Sub-Regional RTEP Committee PJM South

SRRTEP - South
July 26, 2016

Dominion Transmission Area

B1696 Cost Increase and Scope Addition

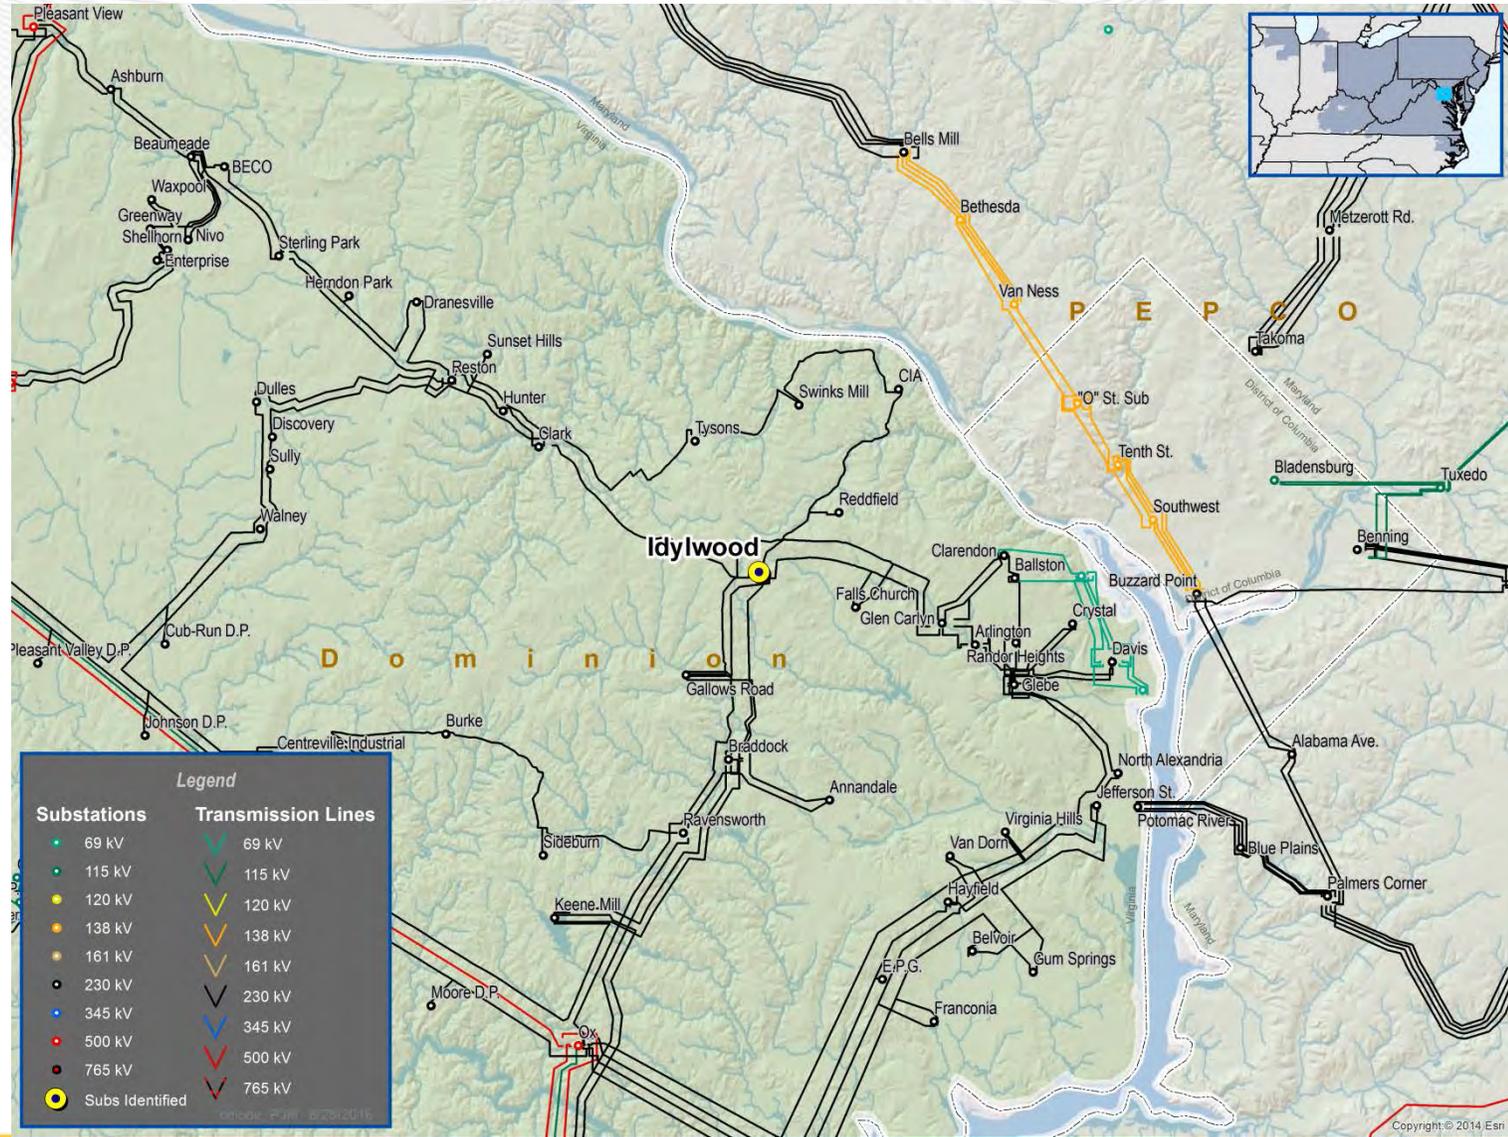
Reason for cost increase:

- Detailed cost estimate included additional cost due to GIS breakers, security wall, transmission structures, labor, and permitting.

Previous Cost Estimate: \$55 M

Revised Cost Estimate: \$80 M

Existing B1792 Cost Increase and Scope Modification

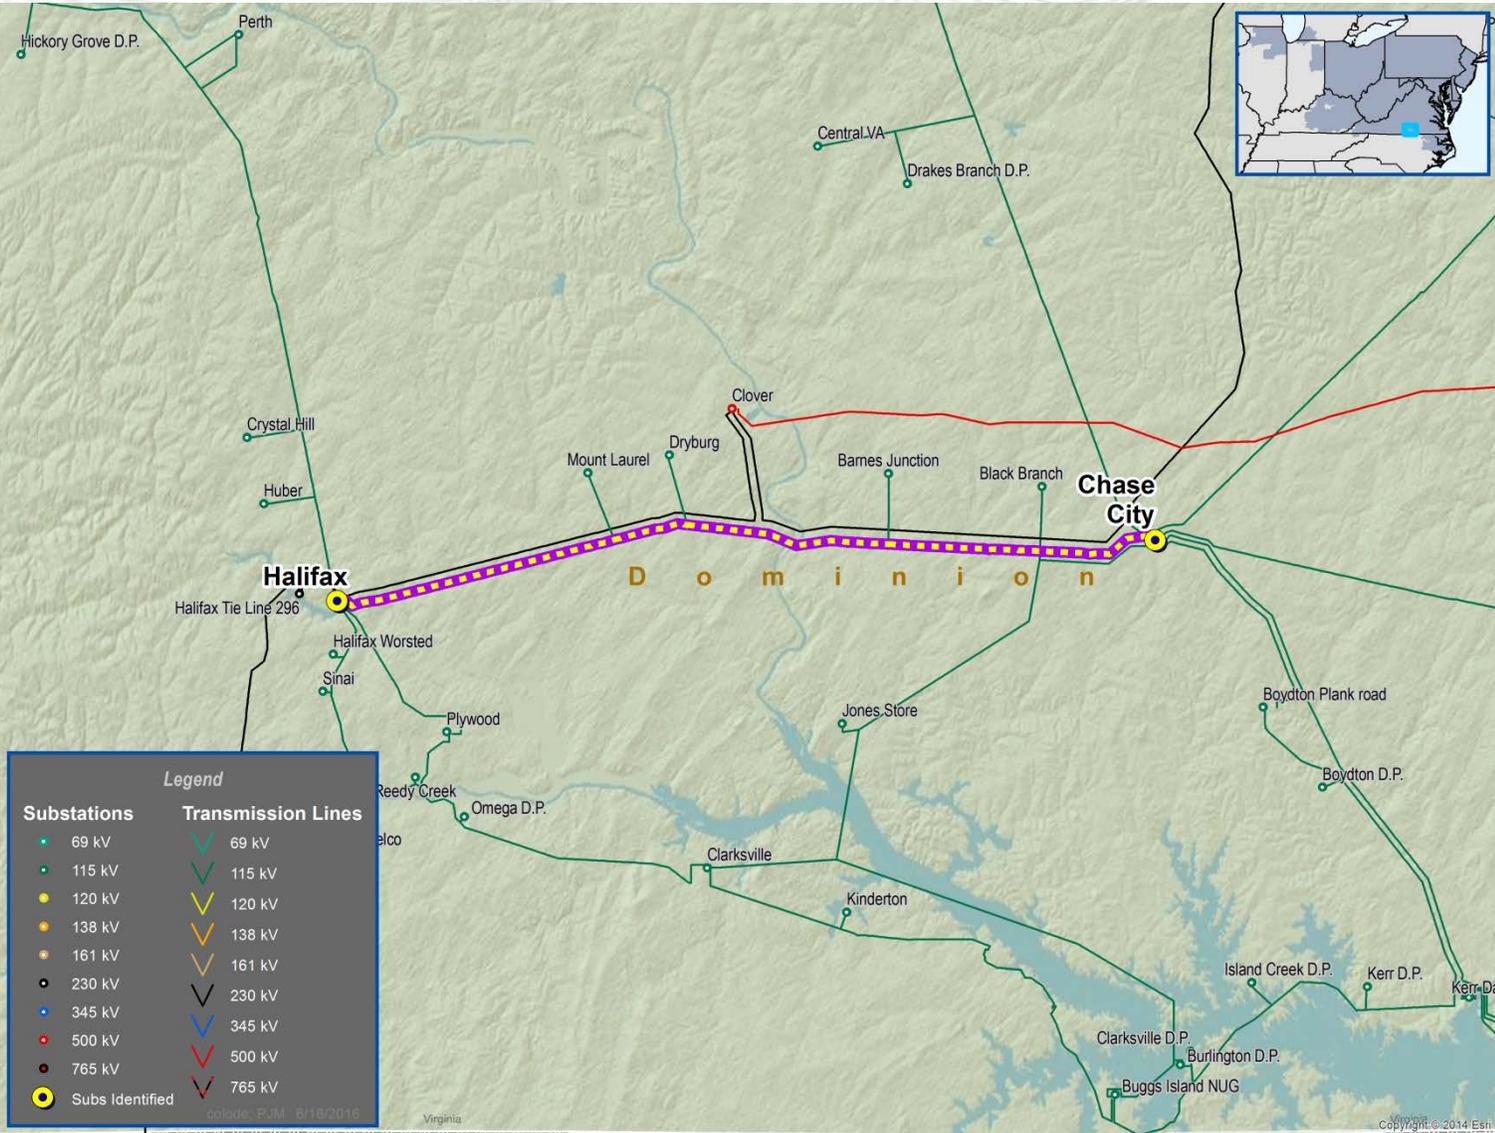
Reason for Revision:

- The original plan was to expand Halifax substation. Halifax substation cannot be expanded because it is located in a flood plain.

Proposed Revised Solution:

- Rebuild Line #33 Chase City – Halifax 230kV to a minimum summer emergency rating of 300 MVA.
- Relocate Halifax switching station out of the flood plain
- Build a new switching station, to be called Sedge Hill, with 230kV four breaker ring and a 115kV breaker and a half scheme with seven breakers.

Existing B2186 Cost Increase and Scope Modification

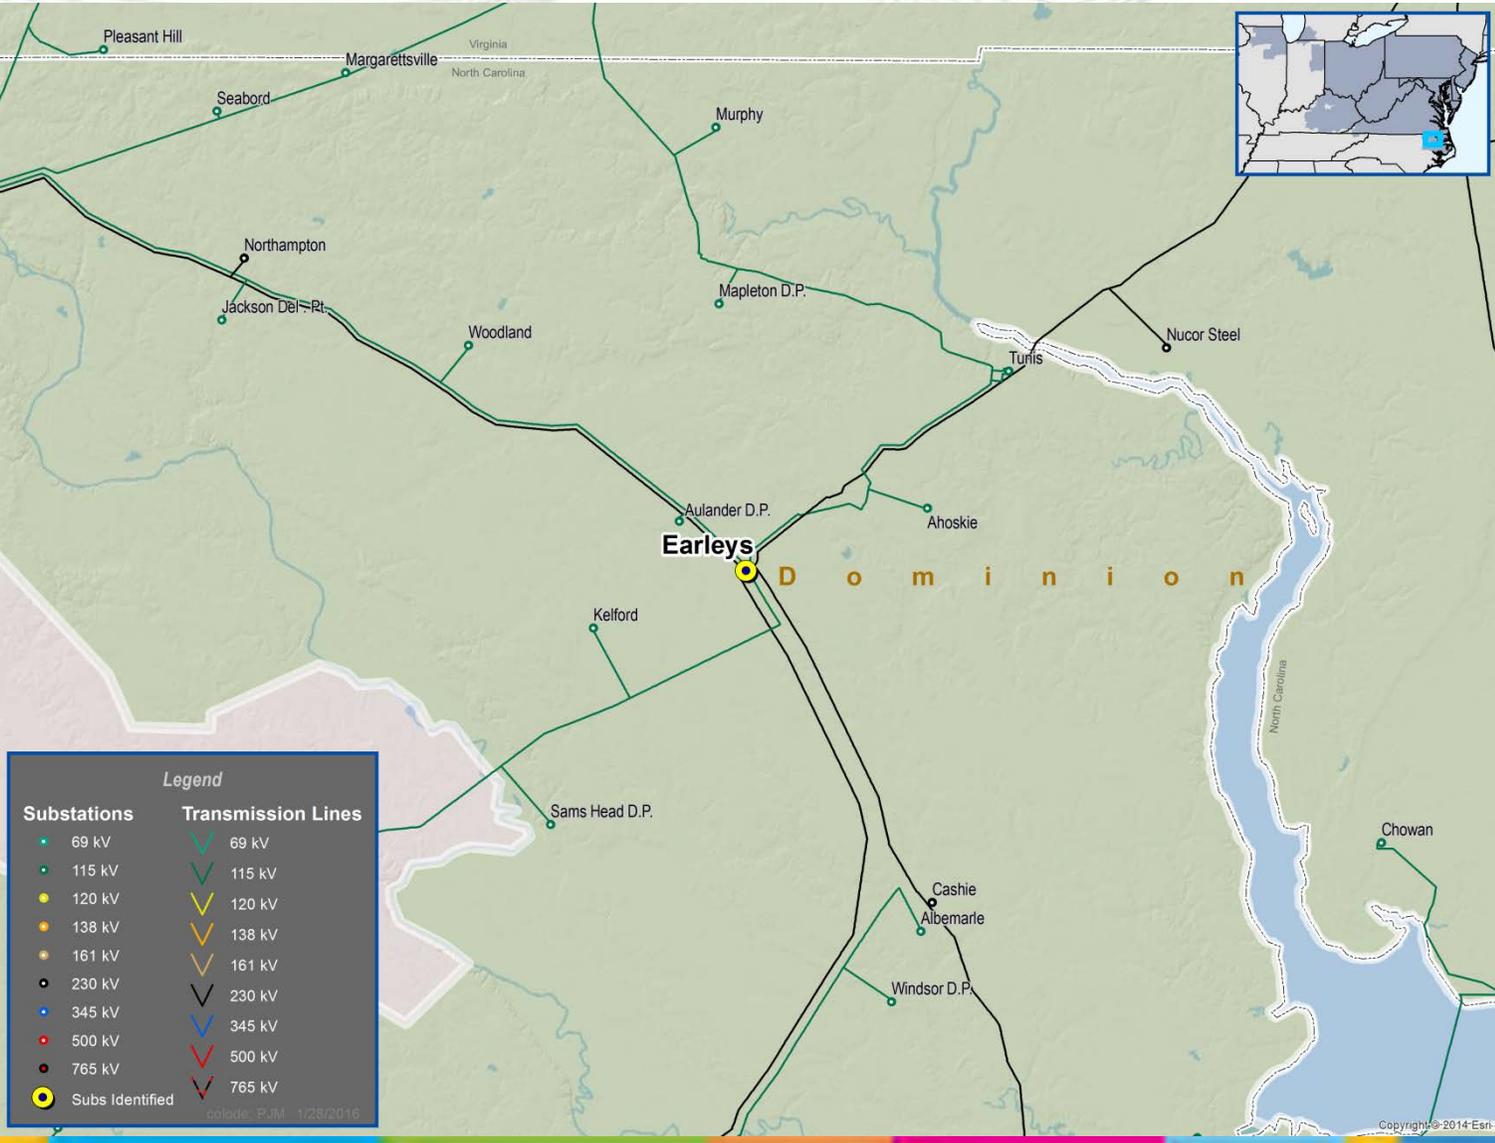
Reason for cost increase:

- Dominion design guidelines require that wood pole structures inside the station be replaced when there is a project at a substation.
- Therefore, four wood pole structures need to be replaced at Earleys.
- Two spans of conductor will be replaced on line #2012 Earleys- Roanoke Valley 230kV at Earley's substation that will increase the summer STE rating from 595 to 608 MVA.
- Due to additional DC load requirements from this project and previous projects and no room for expansion in the existing control house, a new battery enclosure is required.

Existing B2458 Cost Increase and Scope Modification

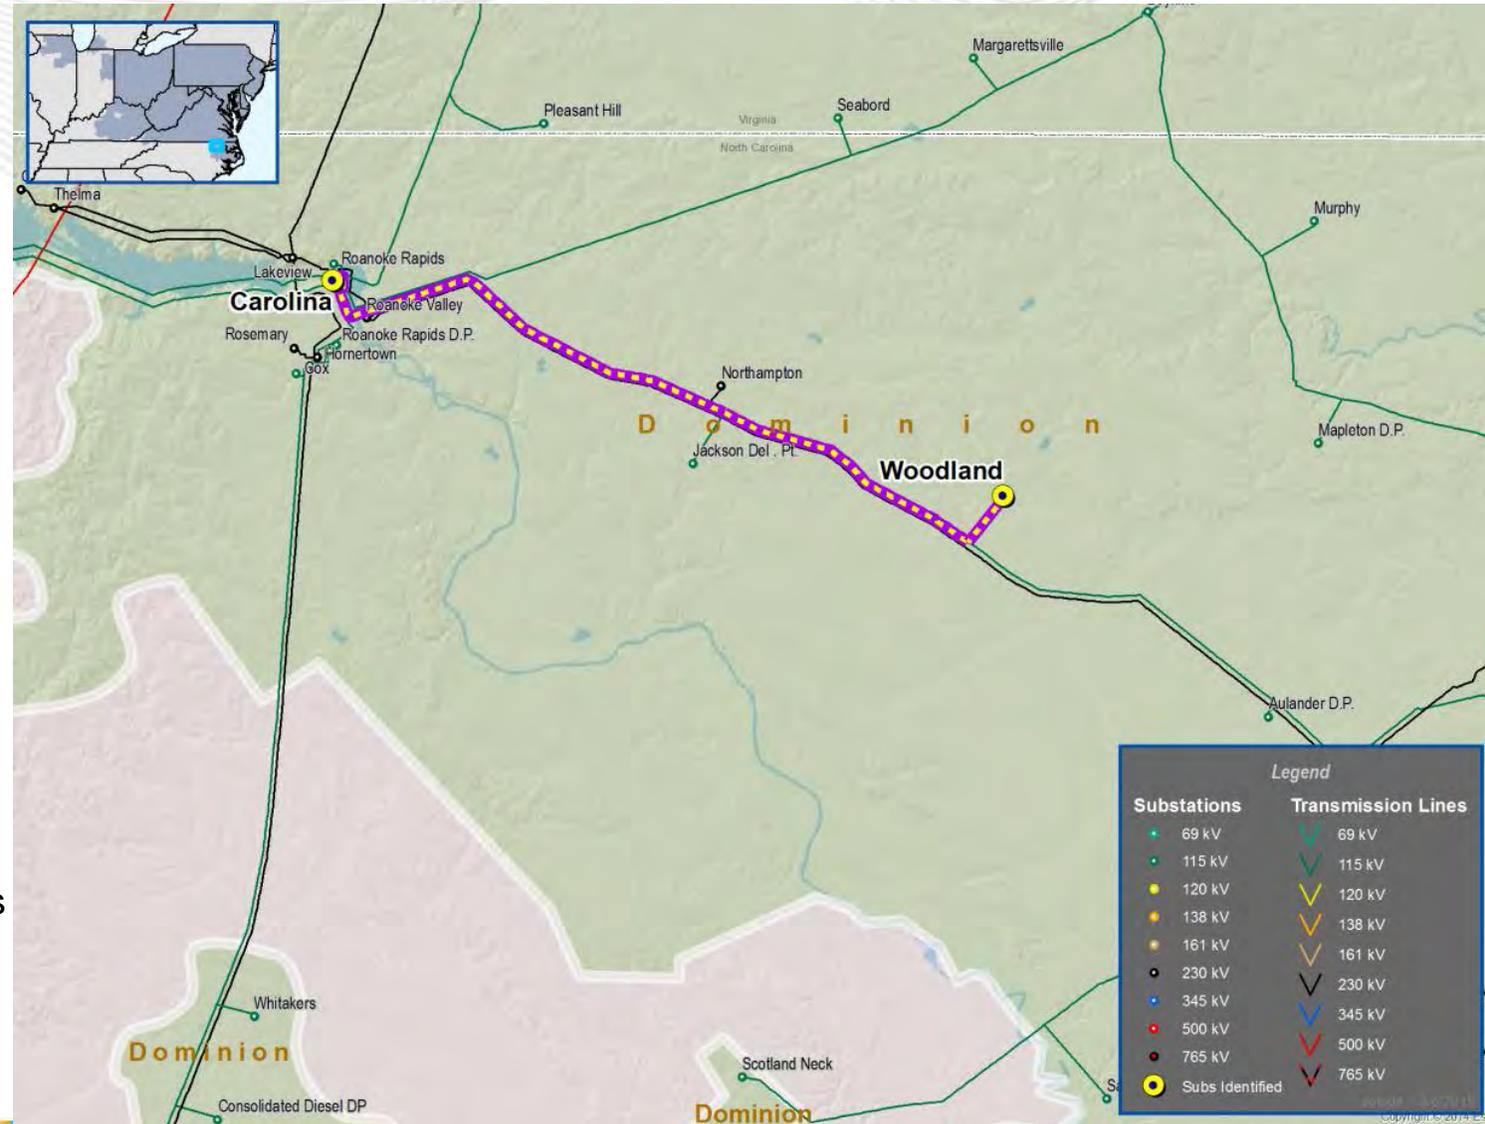
Construction Update:

- Broken strands at multiple locations along Carolina – Woodland 115kV circuit discovered during construction that need to be replaced. **(B2458.6)**

Addition to Project Scope:

- Reconductor 22.4 miles of Carolina–Jackson 115kV for min. 174 MVA summer STE rating using existing structures

Existing B2628 Cost and Scope Modification

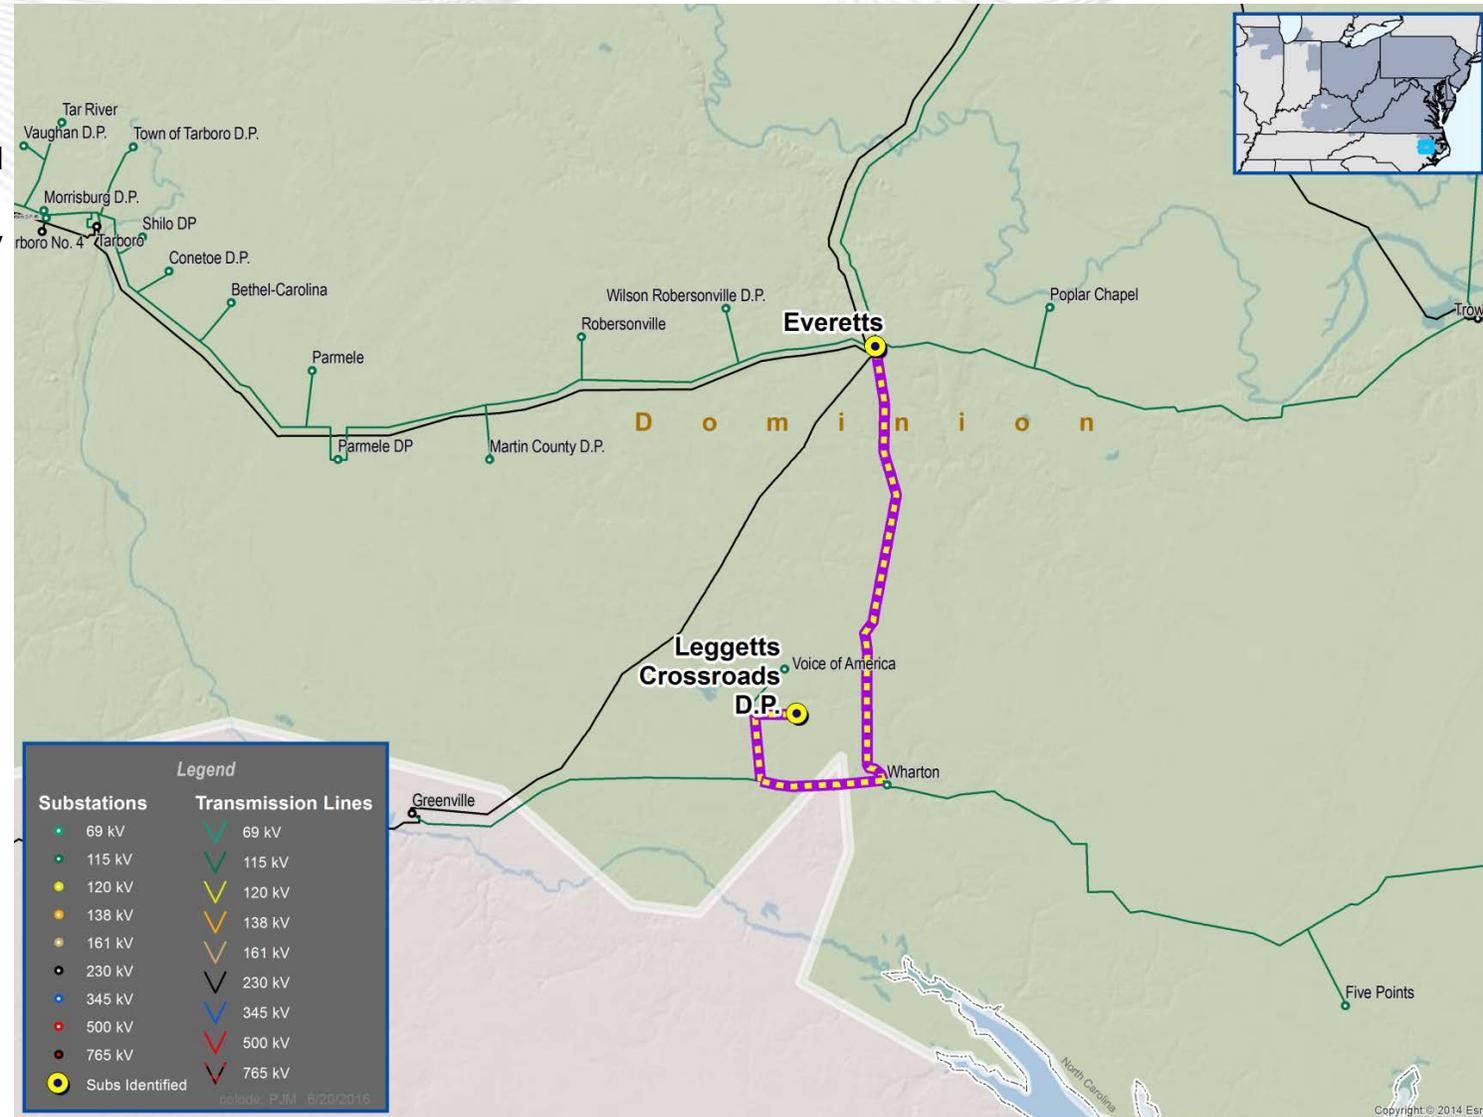
- **Problem DOM “End of Life Criteria”:** The Everetts – Voice of America 115kV line #82 was constructed on wood H-frame structures in 1953. This line has ACSR conductor and 3/8 inch steel static.
- System Impact Assessment - Failure of Line #82 would permanently drop 49 MW of load

Scope Modification:

- Rebuild Everetts – Leggetts 115kV Line #82 Crossroads DP (19.1 miles) to current standards with a summer emergency rating of 353 MVA at 115kV (B2628)
- The cost increase is due to refined detailed cost estimates updates and the increase in line capacity.
- The last 1.75 mile section of Leggetts Crossroad DP to Voice of America (VOA) was removed from this project due to minimal load at VOA and the potential to remove this line section in the future for the load to be served from the distribution system.

S0920 Cost Increase

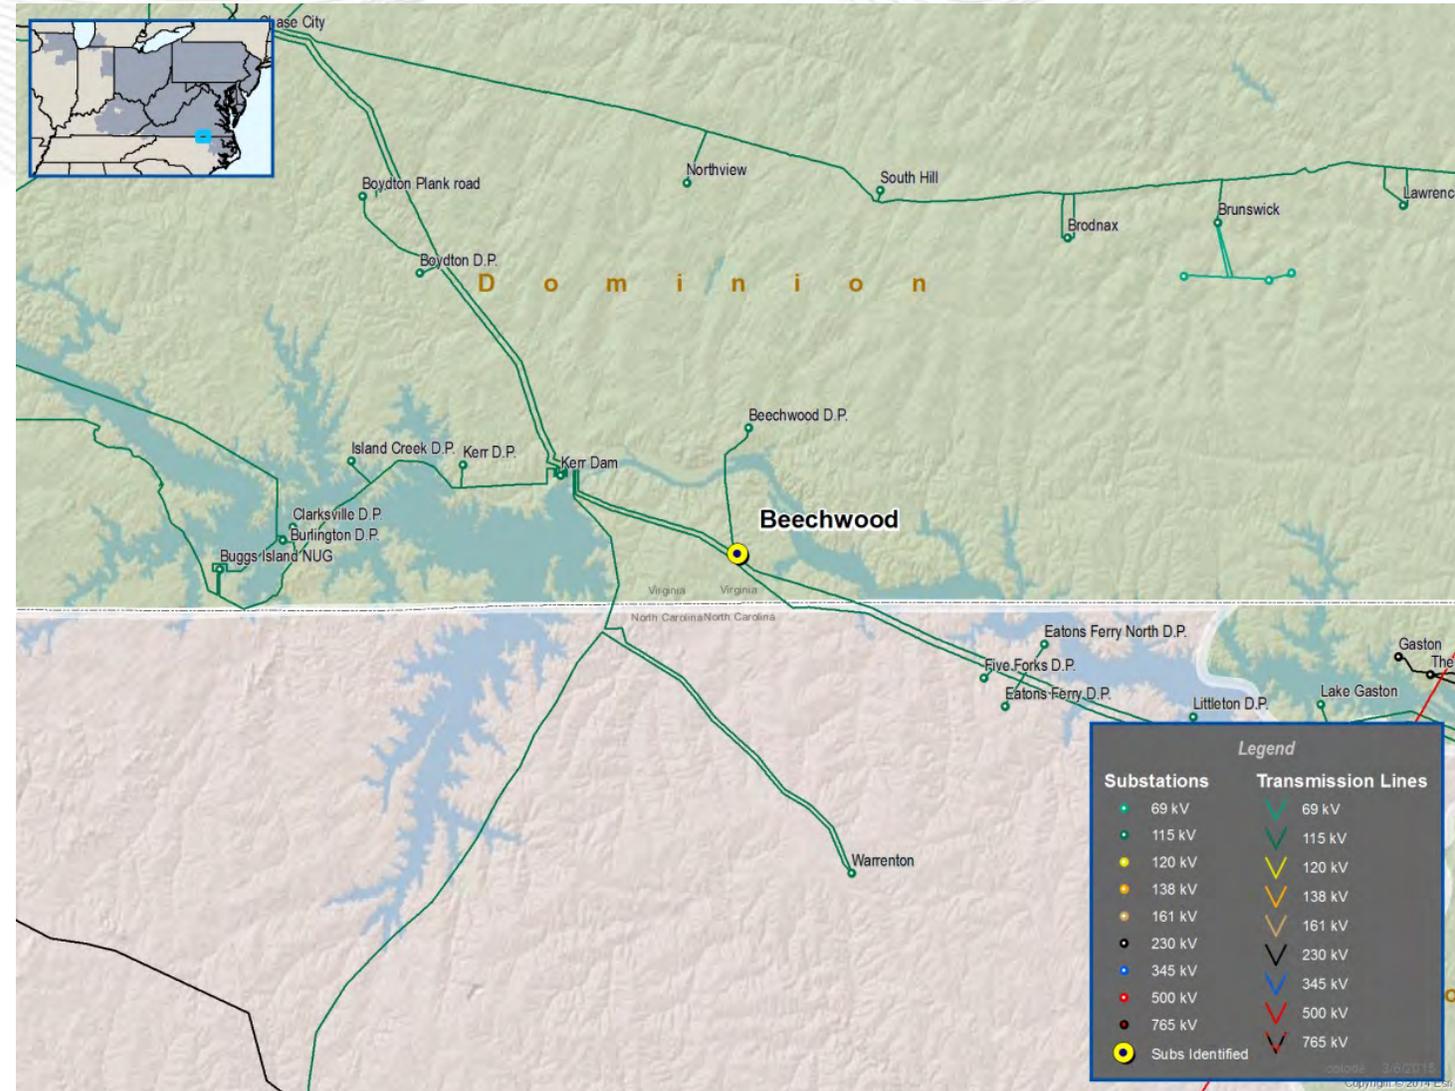
Reason For Cost Increase:

- Detailed cost increase includes higher real estate cost due to larger footprint needed to accommodate the breaker ring.
